September 16, 2009

**SUBJECT:** Submission of Additional U.S. Department of Energy Responses to Requests for Additional Information for the Phase 1 Decommissioning Plan for the West Valley Demonstration Project from U.S. Nuclear Regulatory Commission Review

RESPONSES TO THE  
U.S. NUCLEAR REGULATORY COMMISSION  
REQUEST FOR ADDITIONAL INFORMATION  
ON THE WEST VALLEY DEMONSTRATION PROJECT  
PHASE 1 DECOMMISSIONING PLAN

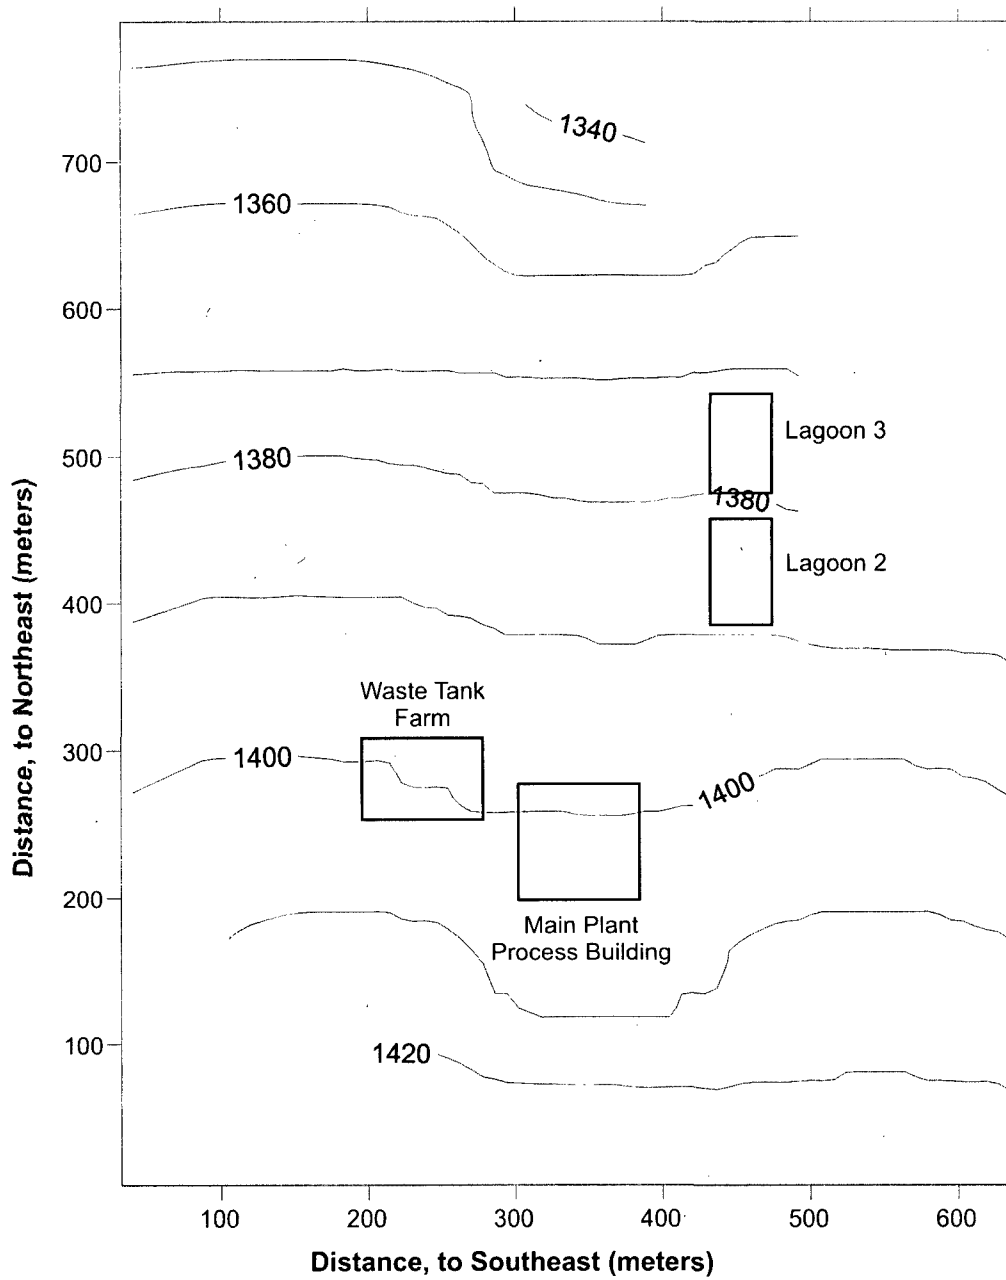
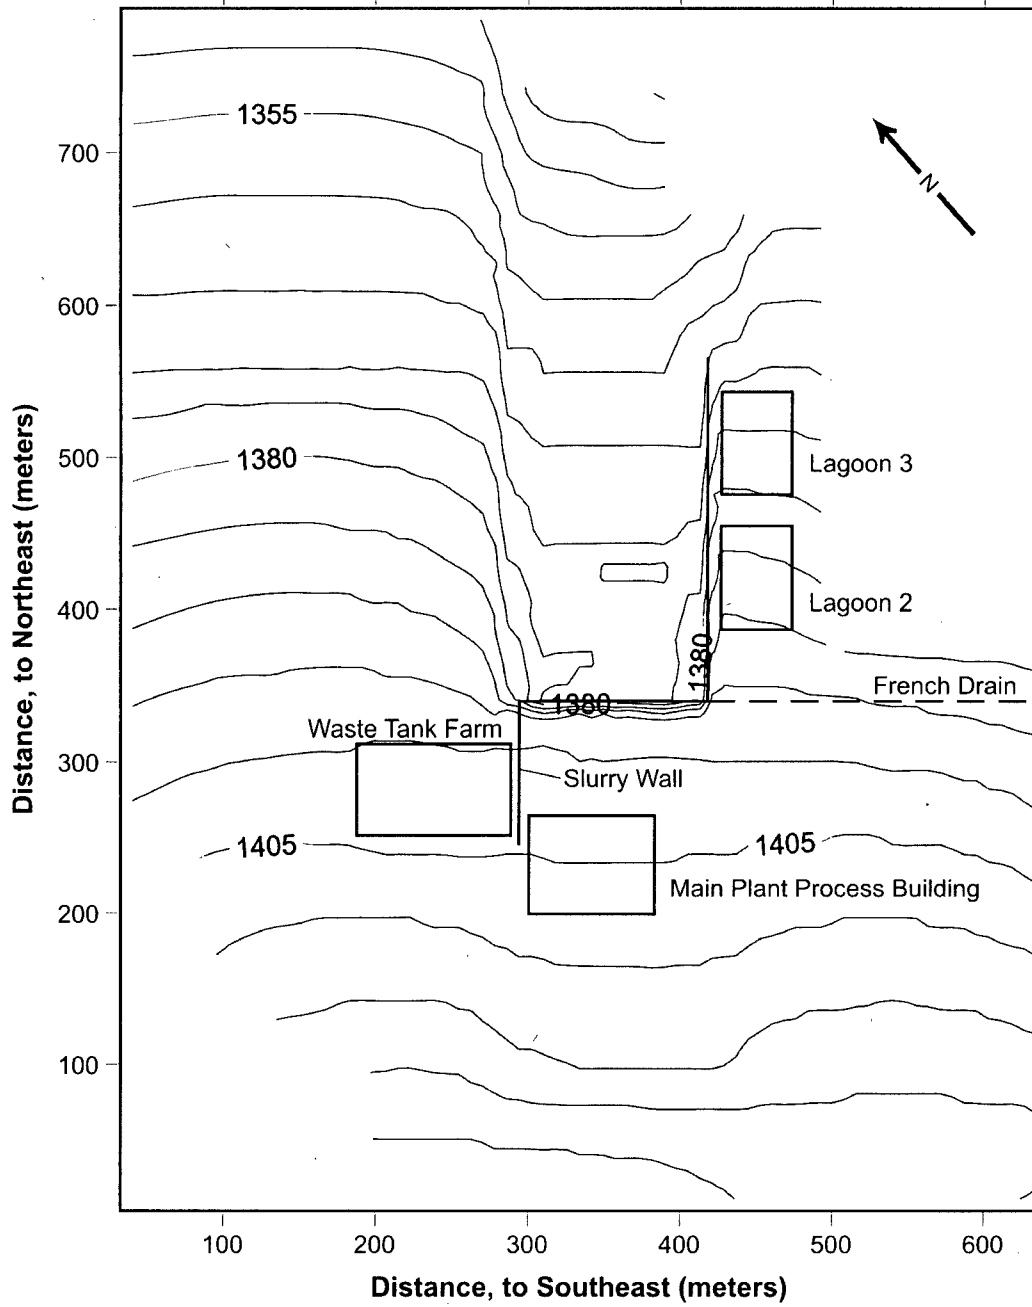
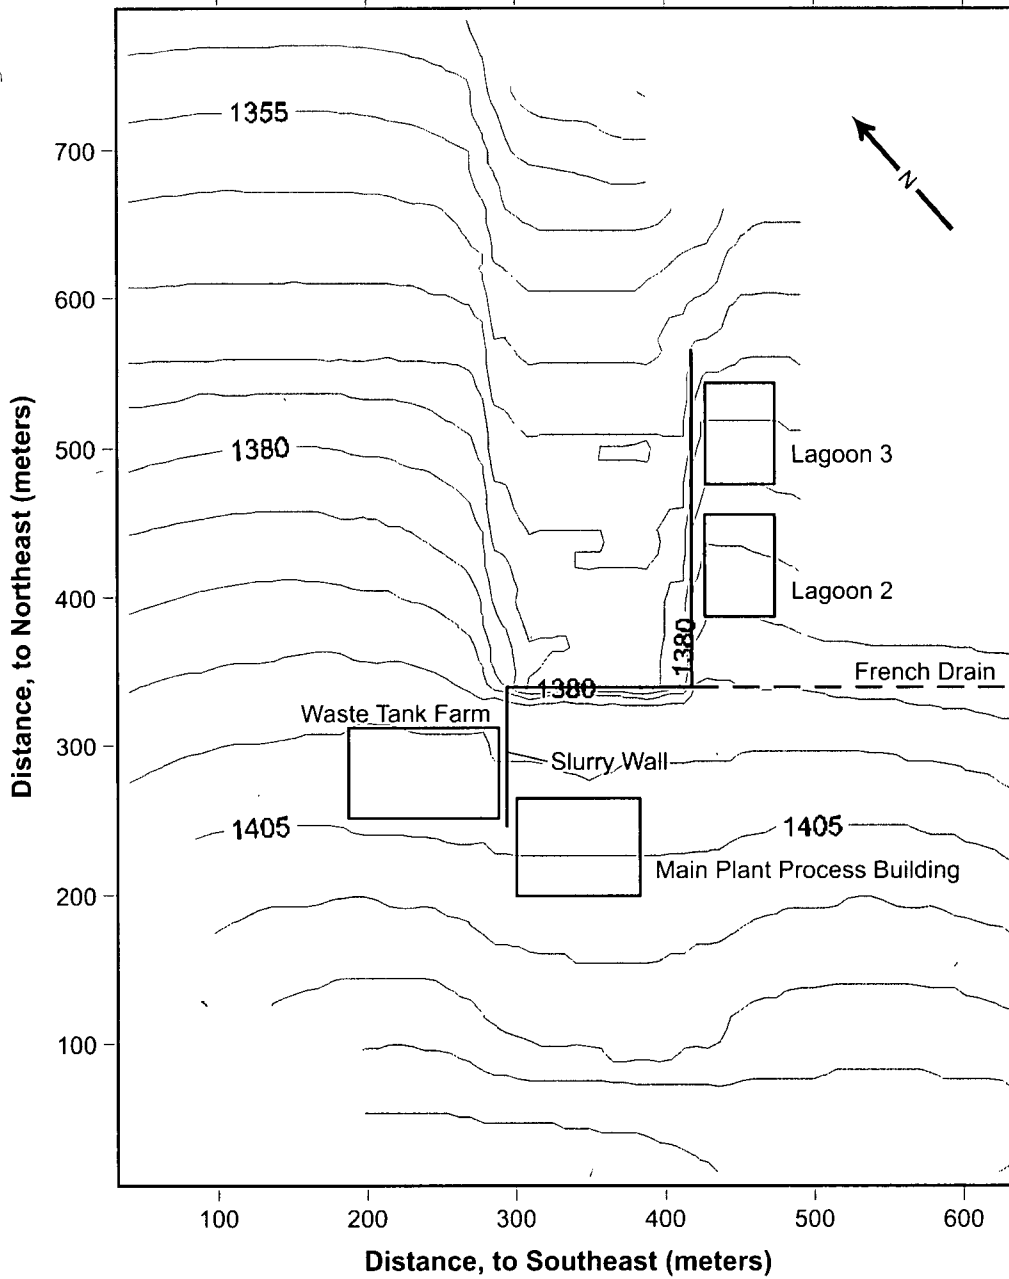
**DOE Response:** DOE has used the three-dimensional near-field STOMP model for the north plateau discussed in Appendix D to the DP to evaluate the impact of hydraulic barriers on the assumed dilution factors for the phased decommissioning alternative as described below.

If the site-wide close-in-place alternative were to be selected for Phase 2 of the decommissioning, the hydraulic barriers installed during Phase 1 would remain in place. The key question under these circumstances would be whether the hydraulic barriers would influence the directions of flow through the aquifer in a manner inconsistent with the aquifer well dilution concept incorporated into the RESRAD model used to establish DCGLs.

This issue has been evaluated using the STOMP three-dimensional near-field flow model. The results show that groundwater flow patterns with the hydraulic barriers in place would not be inconsistent with the RESRAD model and would therefore not impact the calculated DCGLs.

The role of the hydraulic barriers in alteration of the configuration of the water table is illustrated in Figures 5C3-1, 5C3-2, and 5C3-3 for the three cases. At this level of detail, the difference between the case of no barriers (Figure 5C3-1) and presence of barriers (Figures 5C3-2 and 5C3-3) is clear, but little difference can be found for comparison of design and degraded French drain.

Figure 5C3-5 Influence of a Well on Elevation of the Water Table Along a Southwest-to-Northeast Transect Through the Process Building Excavation

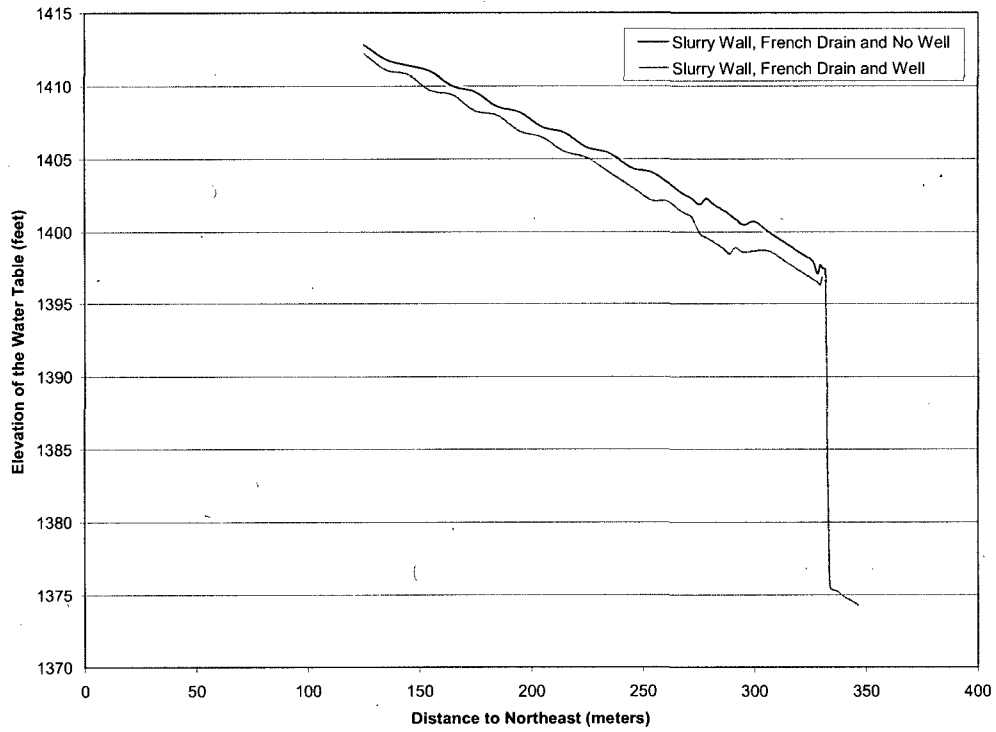
As discussed in a preceding comment, it is recommended that DOE provide results of calculations or perform additional modeling (e.g., multi-dimensional groundwater modeling using STOMP) to show the impacts of (i) a pumping well, and (ii) hydraulic barriers on the flow field in the immediate vicinity of WMA 1 and 2 excavations and potential transport of contaminants from the Lavery Till to a the drinking water well located in the sand and gravel. DOE should also evaluate the potential risk associated with transport of contamination from the Lavery Till to the KRS or to surface water. This information could be used to provide additional support that the potential contributions from subsurface contamination to the overall risk from the site from other pathways of exposure (i.e., drilling scenario) are insignificant.

Elevation of the water table along this transect for the case of design conditions of the barrier wall and French drain without a well and with a well pumping at 5,700 cubic meters per year is presented in Figure 5C3-5. The well was located at position of 280 meters on the horizontal axis of Figure 5C3-5. The results indicate that the presence of the well causes a minor general lowering of the water table and a local drawdown on the order of one meter within a radius of twenty-five meters.

Figure Att-2. Cumulative Probability Dose-Source Ratio, Sr-90 – Surface Soil

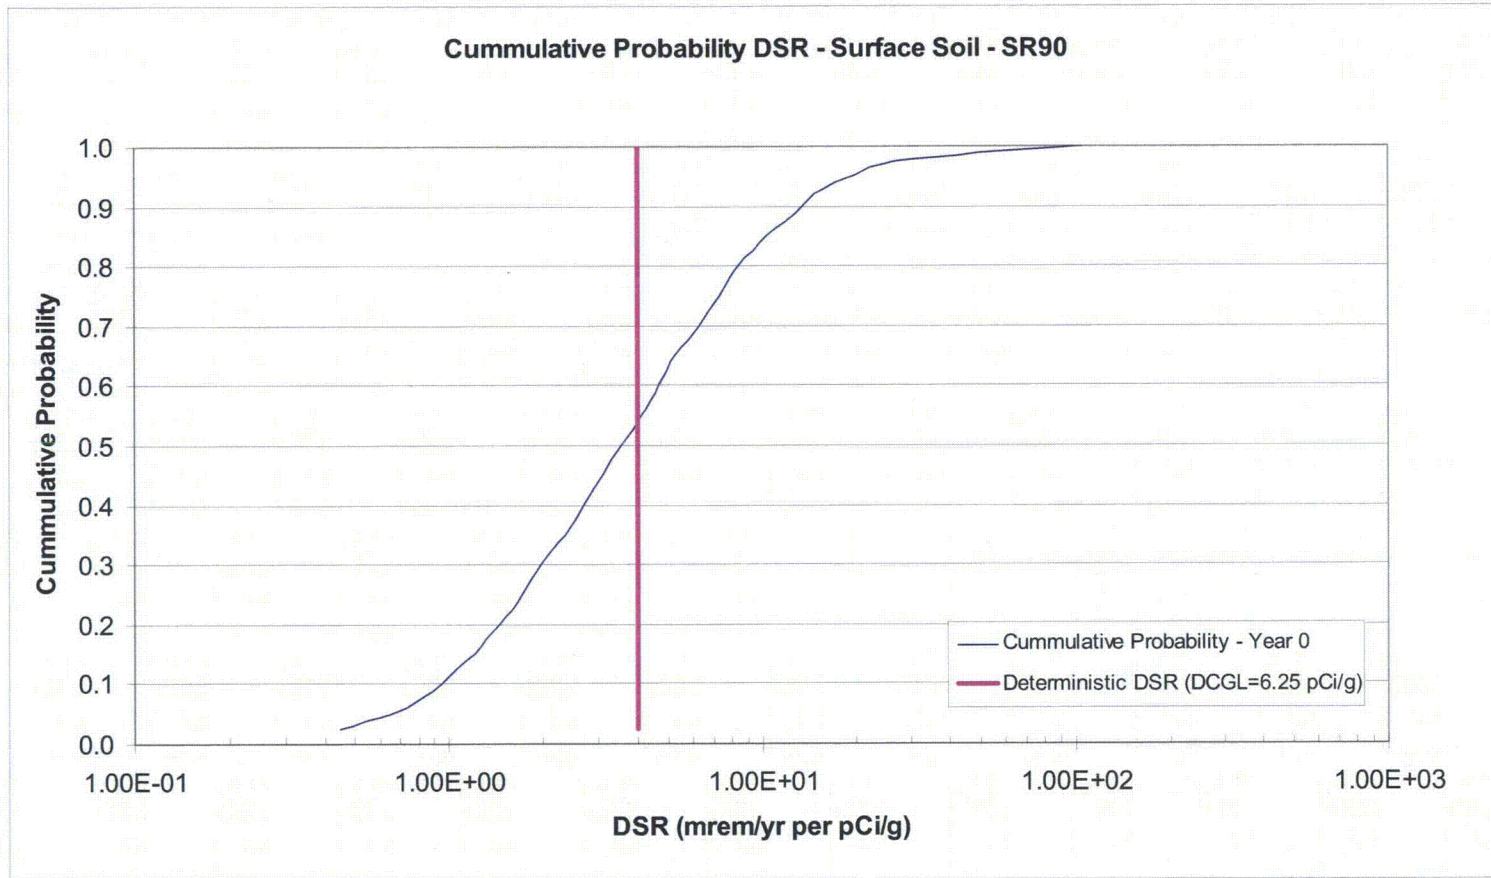
**RAI:** DOE did not provide sufficient support that the selection of parameter values in the deterministic analysis is sufficiently conservative to demonstrate compliance with LTR criteria. (Section 5.2.4)

**Path Forward:** DOE should provide support that the selection of parameter values in the deterministic analysis does not significantly under-predict the potential risk associated with residual material remaining at the site following remediation. Using what limited characterization data is available, DOE should identify the key risk drivers and indicate how the parameter selection is conservative for these radionuclides. In the absence of sufficient information on radionuclide distributions, DOE should consider use of pathway- or radionuclide-dependent parameter sets that would tend to over-estimate rather than under-estimate the potential dose when considering the potential uncertainty associated with the dose calculations.

The lack of conservatism in these surface soil criteria can be quantified in another manner by considering the average soil concentrations at the deterministic DCGLs. If the average residual concentration of Sr-90, for example, were to be 6.25 pCi/g (the deterministic DCGL for surface soil), then the probabilistic modeling would indicate that the probability that the resulting dose would not exceed 25 mrem in the peak year would be approximately 55 percent (see Figure Att-2 in Attachment 1).
